# Access Compliance Report

## Public Rights-of-Way

### (Curb Ramps)

Intersection ID: 42506	Main Street: CHASEWATER_DR	Cross Street: DARBY_CHASE_DR	Location: NE
ADA ID: EDA6CBD73146	Ramp Type: Perp	Initial Pass/Fail: Fail	Overall Compliance: No
			Severity Score: 21.25

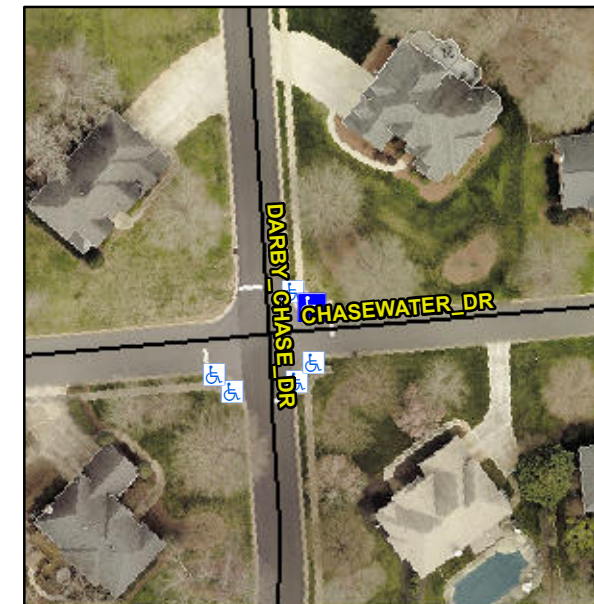
**Not Found, R304.5.1, R304.2.2**

Compliance	Description	Data	Compliance	Description	Data
N/A	Ramp Length (in)	46.0	No	Ramp Slope (%)	9.0
No	Ramp Width (in)	44.5	Yes	Ramp XSlope (%)	1.2
N/A	Flare Type LT	N/A	N/A	Flare Type RT	N/A
N/A	Flare Slope LT (%)	N/A	N/A	Flare Slope RT (%)	N/A
N/A	Flare Traversable LT?	N/A	N/A	Flare Traversable RT?	N/A
N/A	Landing Length (in)	N/A	N/A	DWS Provided?	N/A
N/A	Landing Width (in)	N/A	N/A	DWS Contrast?	N/A
N/A	Landing Slope (%)	N/A	N/A	DWS Length (in)	N/A
N/A	Landing X Slope (%)	N/A	N/A	DWS Full Width?	N/A
N/A	Landing Curb? (Y/N)	N/A	N/A	DWS Offset (in)	N/A
N/A	Shared Landing?	N/A			
N/A	Gutter Ponding?	N/A	N/A	Gutter Slope (%)	N/A
N/A	Gutter Lip Ht (in)	0.5	N/A	Gutter X Slope (%)	N/A
N/A	Painted X Walk1?	No	N/A	Painted X Walk2?	N/A
	X Walk 1 Direction	To S		X Walk 2 Direction	N/A
N/A	X Walk 1 Width (in)	N/A	N/A	X Walk 2 Width (in)	N/A
	X Walk 1 Slope (%)	0.9		X Walk 2 Slope (%)	N/A
	X Walk 1 X Slope (%)	0.6		X Walk 2 X Slope (%)	N/A

**Remove & Replace Entire Ramp.**
